Amendments to the Drawings:

REMARKS

Fig. 6

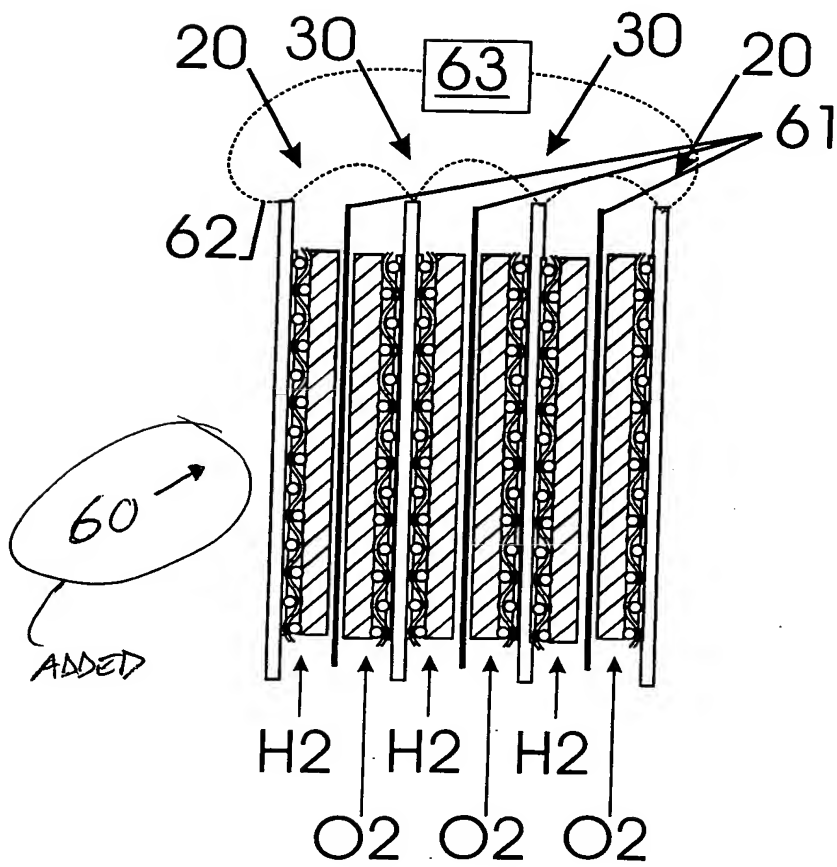
The specific changes which have been made to Figure 6 is to add reference numeral "60."
